PRODUCT / PROCESS CHANGE NOTIFICATION

1.1 Company	 STMicroelectronics International N.V
1.2 PCN No.	MDG/23/14173
1.3 Title of PCN	ST Calamba (Philippines) UFQFPN 7x7 48L package line additional source for STM32G07x/08x, STM32G41x/G47x/48x and STM32C031x listed products
1.4 Product Category	STM32C0x, STM32G0x, STM32G4x.
1.5 Issue date	2023-10-25

**PRODUCT/PROCESS
CHANGE NOTIFICATION
PCN14173**
– Additional information

**ST Calamba (Philippines) UFQFPN 7x7 48L package line
additional source for STM32G07x/08x, STM32G41x/G47x/48x and
STM32C031x listed products**

How can the change be seen?

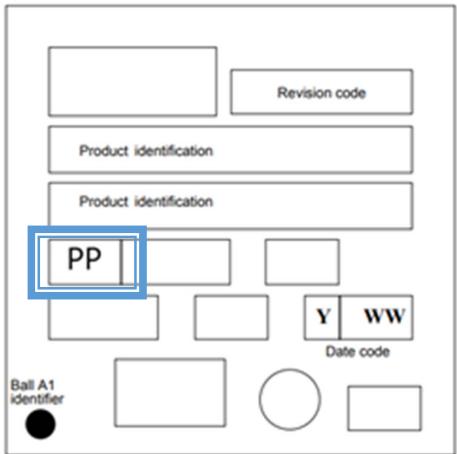
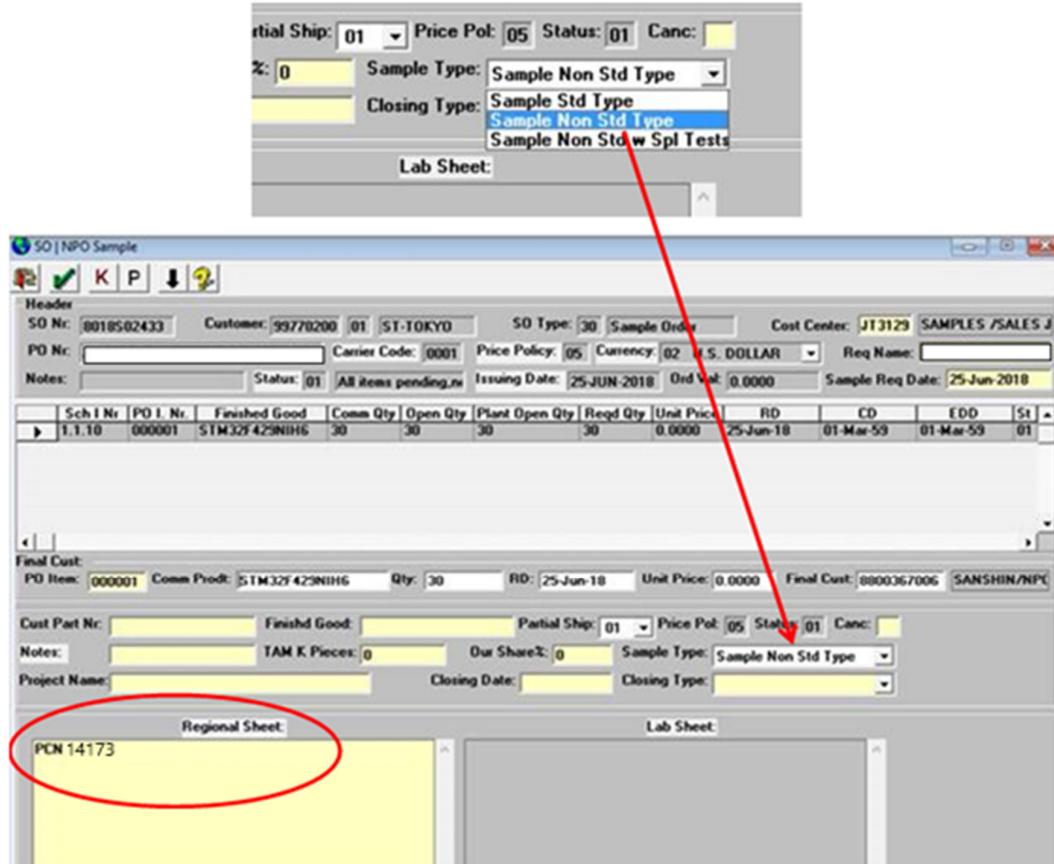
Marking	Existing	Added Back-End Site
UFQFPN 7x7 48L		
PP code	AA: ASE KaoHsiung (Philippines) GQ: Stats ChipPAC JSCC Jiangyin China	78: ST Calamba (Philippines)

Y WW code indicates Year Week (manufacturing date)

PP code indicates assembly traceability plant code.
